# *City of Canby*

## Canby OR 99E Corridor and Gateway Plan Community Meeting #2 – Meeting Summary

**CANBY GATEWAY DESIGN PLAN  
COMMUNITY MEETING COMMENTS  
Otak Project #16010**

## Canby OR 99E Corridor and Gateway Design Plan

***Berg Parkway Gateway (2)***

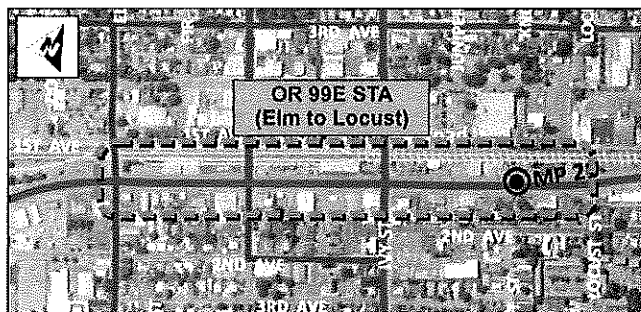
- The existing gateway is a great start to build on
- Would be nice to improve the traffic situation in the “goofy” area by the high school
- Like the additional treatments and how they enhance the current gateway – rendition looks really good

- Like the current gateway; additional improvements may be nice but not necessary
- A median may encourage high school students to be even more willing to cross than they already are

- Any discussion of overhead lines? Can they be moved to one side? This would be a huge visual benefit
- Landscaping looks ice but what about maintenance? Other cities seem to be taking out landscaping and putting in pavement

- Prefer stamped concrete rather than bricks (move around) especially for walkways and crosswalks to emphasize pedestrian crossings
- Ask the experts about roadway paving – those who install and repair. Ideas are good, but realize who the real experts are

#### Standard Special Transportation Area (STA)

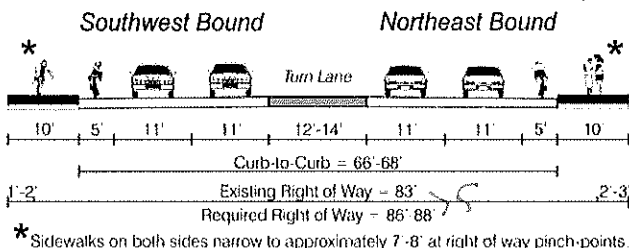
*We'll never get the right-of-way. Bikes don't like busy on 99E anyway*

#### Standard Special Transportation Area (STA)

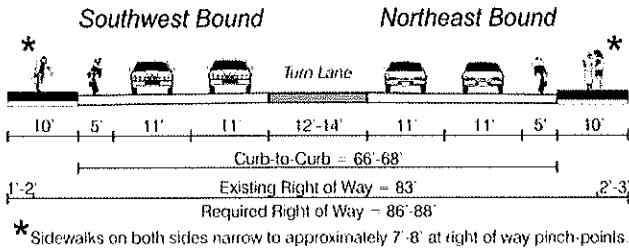
no bike lanes  
bring them through downtown on 1<sup>st</sup> Ave

#### Standard Special Transportation Area (STA)

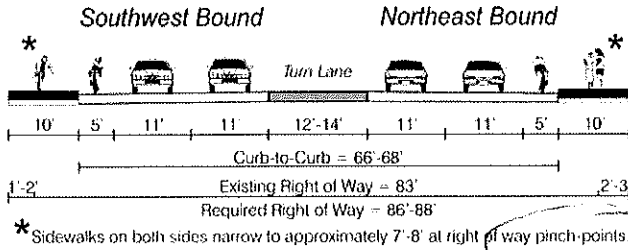
Comments: - No bike lanes on 99E.

#### Wide Sidewalks for Pedestrians/Bikes

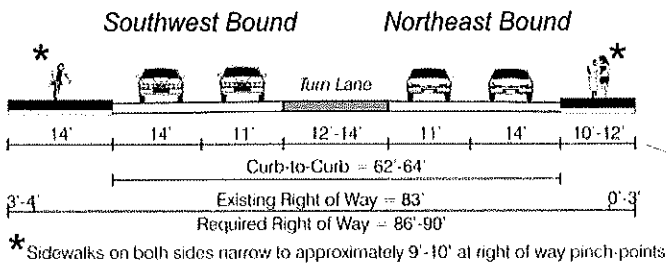
Comments: - No bike lanes on 99E  
- 10'-12' on both sides

#### Buffered Bike Lanes

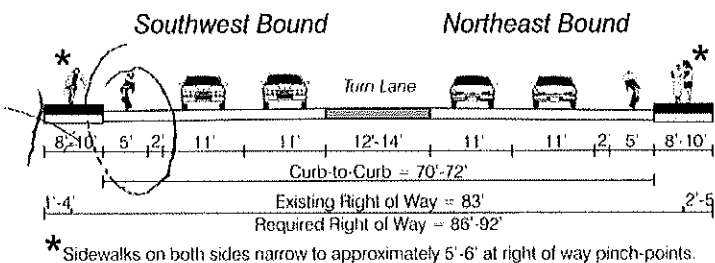
Comments: - No bike lanes on 99E

#### Wide Sidewalks for Pedestrians/Bikes

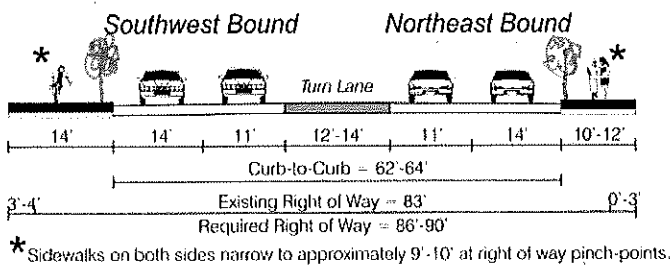
Bikes rarely use 99 thru Canby  
re-route them off to 1st Ave  
Add trees to separate sidewalk users  
from roadway

#### Standard Special Transportation Area (STA)

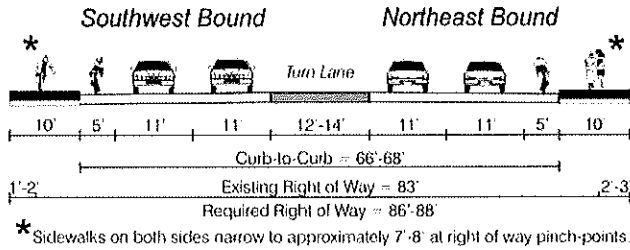
NO Bike lane  
10-12 Sidewalk
